IN THE DRAWINGS:

REMARKS/ARGUMENTS

Fig. 8

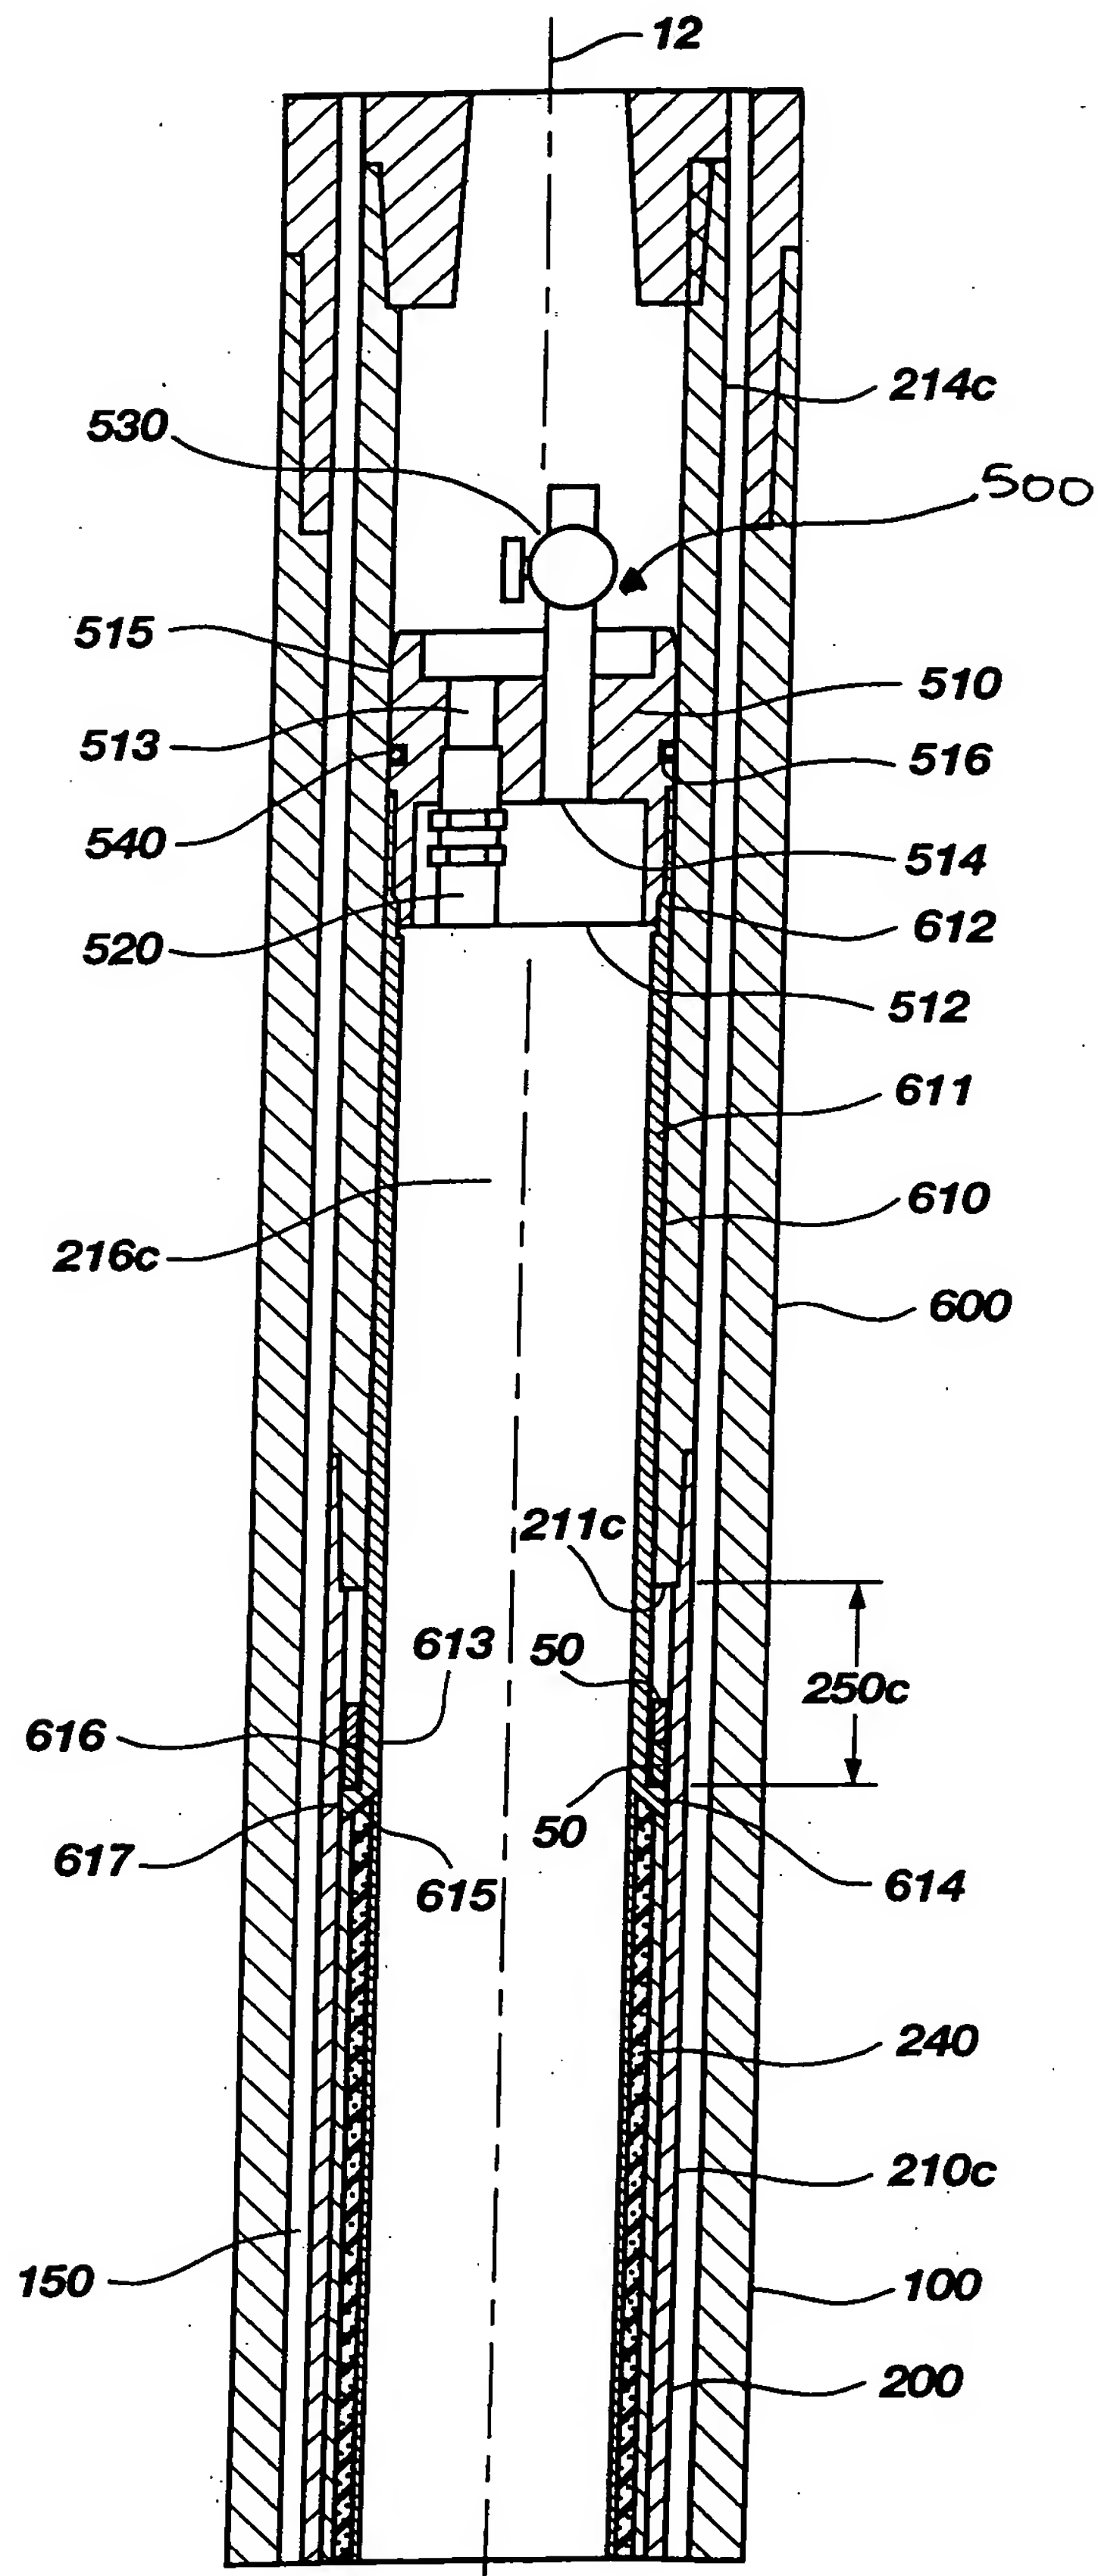
The attached sheet of drawings includes changes to FIG. 8. The attached sheet replaces the previous drawing sheets submitted for FIG. 8. In FIG. 8, previously omitted element 500 has been added. (See attached Replacement Sheet(s) and Annotated Sheet(s) Showing Changes.)

The drawings have been objected to under 37 CFR 1.84(p)(5) for not including reference numeral 500 mentioned in the description. Applicants respectfully traverse, in that reference numeral 500 is already shown in drawing FIGS. 1C and 12C, but has been added to amended FIG. 8, the latter submitted with this amendment, to further address the Examiner's concerns.
